ADDENDUM No. 1 – March 25, 2026

DATE: 03/23/26
DRAWING NUMBER:
ADD-01
A-001

PROJECT TITLE:
Tufts Vet Tech Clinic Renovation
Worcester Technical High School
1 Officer Manny Familia Way, Worcester, MA 01605

Electrical Demolition Ground Floor Ceiling Plan

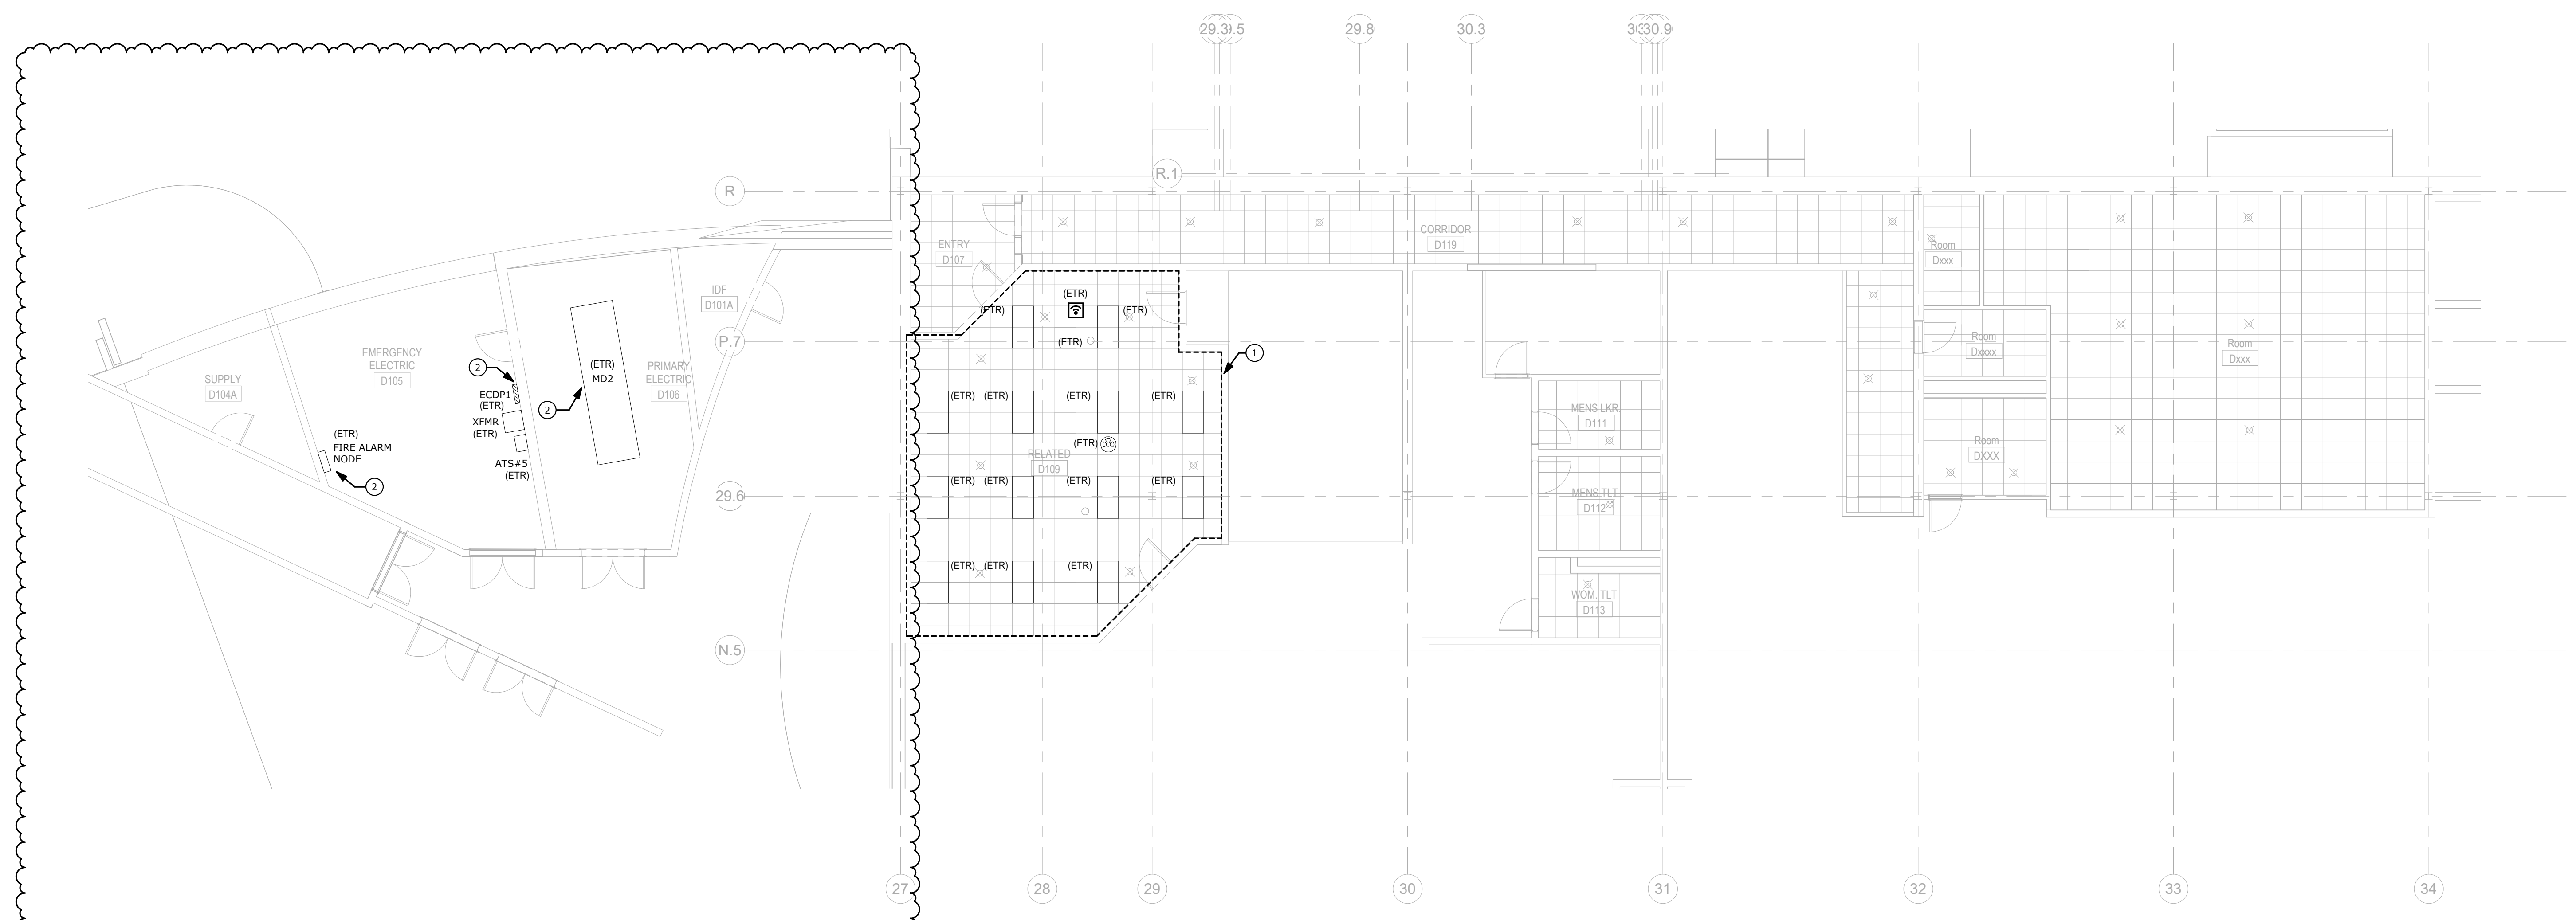
- A. Expand drawing showing Emergency Electric D105 and Primary Electric D106
- B. Add Key Plan to show locations of existing FACP, Admin Room, Electrical Rooms D105 & D106, Existing FA annunciator, a scope of work area.

| QUESTION | RESPONSE |
|--|--|
| <p>Please provide a drawing detailing the location of Electrical Rooms D 105 and D 106 in relation to the area of work.</p> | <p>See Part 3, note 7 of this addendum.</p> |

| QUESTION | RESPONSE |
|---|--|
| Please provide a drawing showing the location of the FA control panel and FA Node #1 servicing the renovated space. | See Part 3, note 7 of this addendum. |
